IS F

OUTLINE OF NEW FEATURES

The following changes have been made for the 2010 model year.

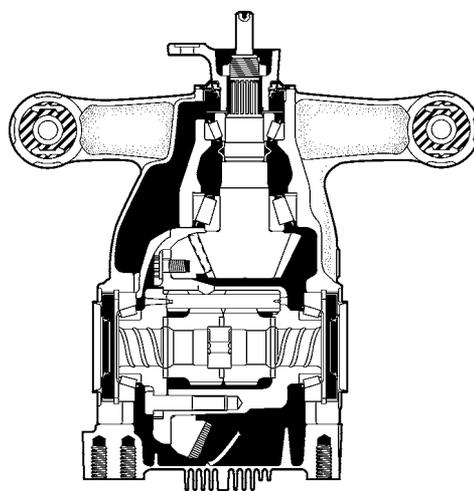
- The ECM software has been modified in accordance with the adoption of permanent Diagnostic Trouble Codes (DTCs).
- Permanent DTCs are used for DTCs associated with the illumination of the Malfunction Indicator Lamp (MIL). Permanent DTCs can not be cleared by using the Techstream. For details, refer to the Repair Manual.

13U0NF03C

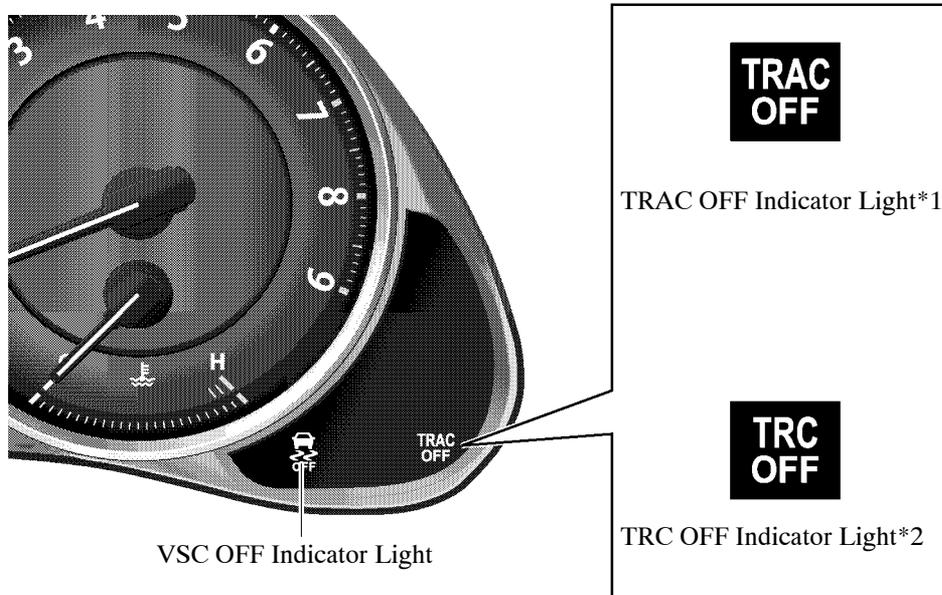
With the introduction of the Safety Connect, the front seat illumination has been discontinued and the lights that operate for of the illuminated entry system have been changed from the front seat illumination to the front interior lights for U.S.A. models.
